# Access Compliance Report

## Public Rights-of-Way

| Intersection ID: 13618                  | Main Street: S_CALDWELL_ST | Cross Street: TEMPLETON_AV              | Location: E            |
| ADA ID: 440E53895236                    | Ramp Type: Directional1    | Initial Pass/Fail: Pass                 | Overall Compliance: No |

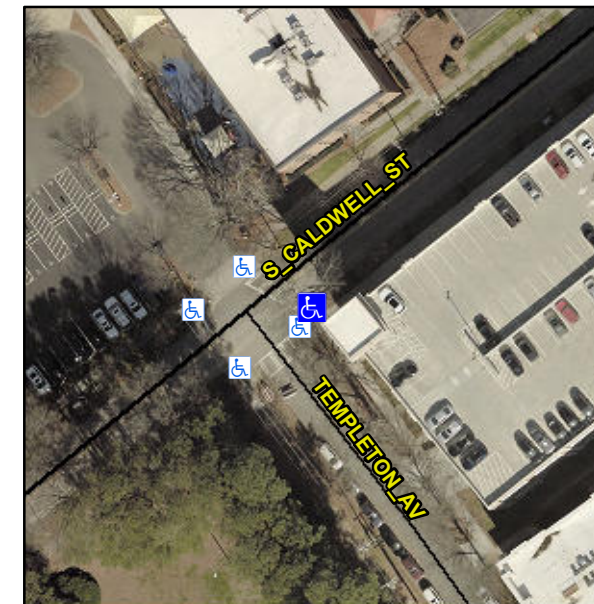
**Remove & Replace Detectable Warning System.**

**R305.2**

| Compliance | Description           | Data  | Compliance | Description                 | Data |
|------------|-----------------------|-------|------------|-----------------------------|------|
| N/A        | Shared Landing?       | Yes   | No         | DWS Offset RT (in)          | 12.0 |
